Access Compliance Report

Public Rights-of-Way

Intersection ID: 46197	Main Street: FERNSPRAY_RD	Cross Street: SEVEN_OAKS_DR	Location: W
ADA ID: 768766DA3C63	Ramp Type: Perp	Initial Pass/Fail: Fail	Overall Compliance: No
		Severity Score: 10

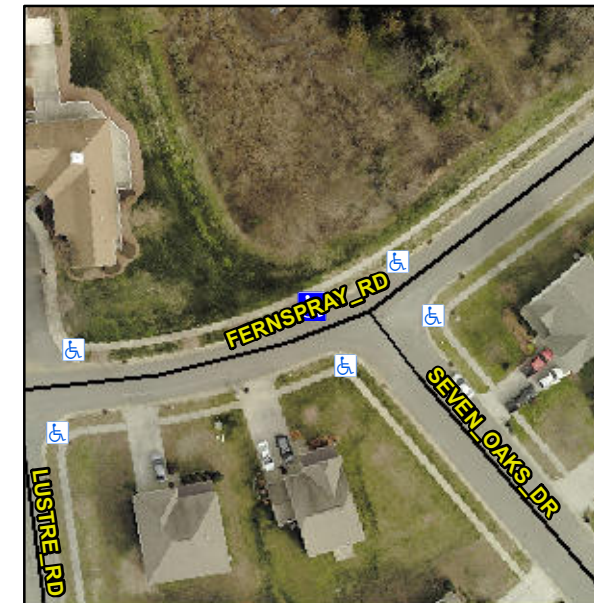
Not Found, R304.5.1

Compliance	Description	Data	Compliance	Description	Data
N/A	Ramp Length (in)	72.0	Yes	Ramp Slope (%)	5.6
No	Ramp Width (in)	45.5	Yes	Ramp XSlope (%)	3.2
N/A	Flare Type LT	N/A	N/A	Flare Type RT	N/A
N/A	Flare Slope LT (%)	N/A	N/A	Flare Slope RT (%)	N/A
N/A	Flare Traversable LT?	N/A	N/A	Flare Traversable RT?	N/A
N/A	Landing Length (in)	N/A	N/A	DWS Provided?	N/A
N/A	Landing Width (in)	N/A	N/A	DWS Contrast?	N/A
N/A	Landing Slope (%)	N/A	N/A	DWS Length (in)	N/A
N/A	Landing X Slope (%)	N/A	N/A	DWS Full Width?	N/A
N/A	Landing Curb? (Y/N)	N/A	N/A	DWS Offset (in)	N/A
N/A	Shared Landing?	N/A			
N/A	Gutter Ponding?	N/A	N/A	Gutter Slope (%)	N/A
N/A	Gutter Lip Ht (in)	0.5	N/A	Gutter X Slope (%)	N/A
N/A	Painted X Walk1?	No	N/A	Painted X Walk2?	N/A
	X Walk 1 Direction	To S		X Walk 2 Direction	N/A
N/A	X Walk 1 Width (in)	N/A	N/A	X Walk 2 Width (in)	N/A
	X Walk 1 Slope (%)	4.0		X Walk 2 Slope (%)	N/A
	X Walk 1 X Slope (%)	3.2		X Walk 2 X Slope (%)	N/A

Remove & Replace Entire Ramp.
